Access Compliance Report

Public Rights-of-Way

(Curb Ramps)

Intersection ID: 21252	Main Street: W_ARROWOOD_RD	Cross Street: N_I-77_EXIT_3_RA	Location:	N
ADA ID: ECA08A20B67C	Ramp Type: Perp	Initial Pass/Fail: Fail	Overall Compliance: No	Severity Score: 10
Codes/Mitigation Info/Possible Solution		Field Measurements/Component Compliance

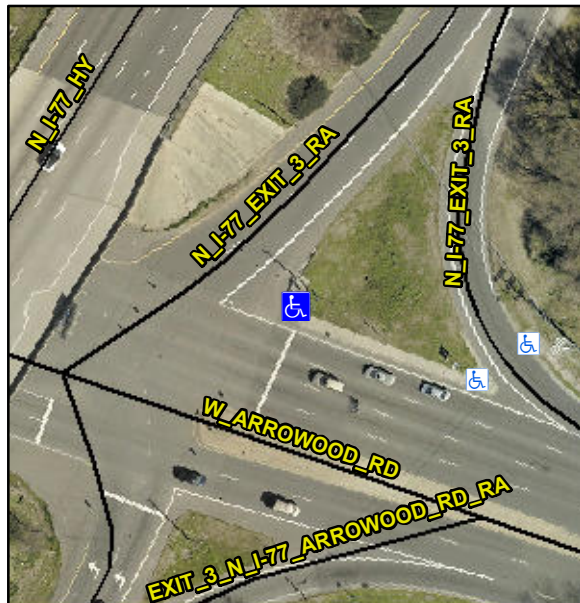
Remove & Replace Entire Ramp.

Not Found, R304.5.1

Compliance	Description	Data	Compliance	Description	Data
N/A	Ramp Length (in)	60.0	Yes	Ramp Slope (%)	6.9
No	Ramp Width (in)	45.0	Yes	Ramp XSlope (%)	2.9
N/A	Flare Type LT	N/A	N/A	Flare Type RT	N/A
N/A	Flare Slope LT (%)	N/A	N/A	Flare Slope RT (%)	N/A
N/A	Flare Traversable LT?	N/A	N/A	Flare Traversable RT?	N/A
N/A	Landing Length (in)	N/A	N/A	DWS Provided?	N/A
N/A	Landing Width (in)	N/A	N/A	DWS Contrast?	N/A
N/A	Landing Slope (%)	N/A	N/A	DWS Length (in)	N/A
N/A	Landing X Slope (%)	N/A	N/A	DWS Full Width?	N/A
N/A	Landing Curb? (Y/N)	N/A	N/A	DWS Offset (in)	N/A
N/A	Shared Landing?	N/A			
N/A	Gutter Ponding?	N/A	N/A	Gutter Slope (%)	N/A
N/A	Gutter Lip Ht (in)	N/A	N/A	Gutter X Slope (%)	N/A
N/A	Painted X Walk1?	No	N/A	Painted X Walk2?	N/A
	X Walk 1 Direction	To W		X Walk 2 Direction	N/A
N/A	X Walk 1 Width (in)	N/A	N/A	X Walk 2 Width (in)	N/A
	X Walk 1 Slope (%)	0.7		X Walk 2 Slope (%)	N/A
	X Walk 1 X Slope (%)	3.0		X Walk 2 X Slope (%)	N/A
